CHANGES FROM SCHEME PERMITTED UNDER ABP-307415-20 - SECOND FLOOR

**PROPOSED
SECOND FLOOR**

LISIEUX PARK

Project		RESIDENTIAL APARTMENTS, LISIEUX PARK		6-7 HARDCOURT TERRACE, DUBLIN 2, IRELAND	
Drawing Title		Murphystown Road, leopoldstown, Dublin 18		1 + 303-1-616 2400 1 + 303-1-616 7385	
				www.bkd.ie	
Proposed Second Floor Plan					
Stage		Planning		03.04.2023	
Scale		1:200@A1			
Drawn		SR			
Zone		FF			
Level		03.04.2023			
Type		DR			
Dis		A			
Sheet no.		1100			
Status		P03			
Rev					
Project Code		6275			
Job		LIS - BKD			
Origin		00			
Level		02			
Type		DR			
Dis		A			
Sheet no.		1100			
Status		P03			
Rev

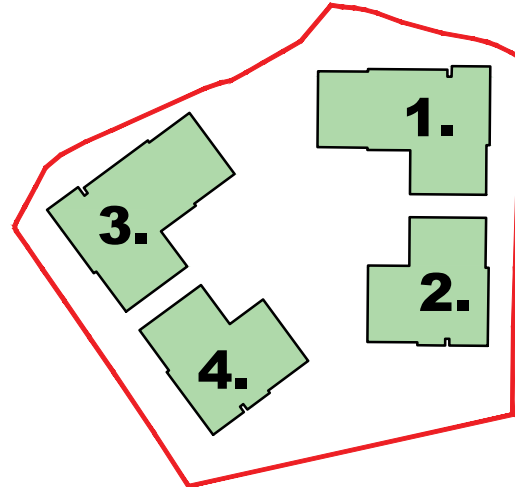
THE FOLLOWING UNITS CONVERTED FROM STUDIOS TO 1 BED UNITS (WITH ADJACENT 1 BED UNITS REDUCED IN SIZE).

BLOCK 1 - UNIT 68 (& 69)
BLOCK 2 - UNIT 79 (& 78)
BLOCK 3 - UNIT 83 (& 94)
BLOCK 4 - UNIT 100 (& 101)

RECONFIGURATION OF LIFT/STAIR CORES TO COMPLY WITH DAC/FSC REQUIREMENTS.

EN-SUITES REMOVED FROM ALL 2 BED UNITS TO ALLOW SPACE FOR APARTMENT FRONT DOORS TO MOVE CLOSER TO THE PROTECTED CORE AND COMPLY WITH THE FSC.

CORRIDOR LENGTHS REDUCED AND DOORS MOVED CLOSER TO CORES TO ALL GABLE 2 BED UNITS TO SATISFY TRAVEL DISTANCES TO SUIT FSC.

ALL PERMITTED BEDROOM DOORS OPENING ON TO BALCONIES CHANGED TO WINDOWS TO IMPROVE SAFETY AND SECURITY.
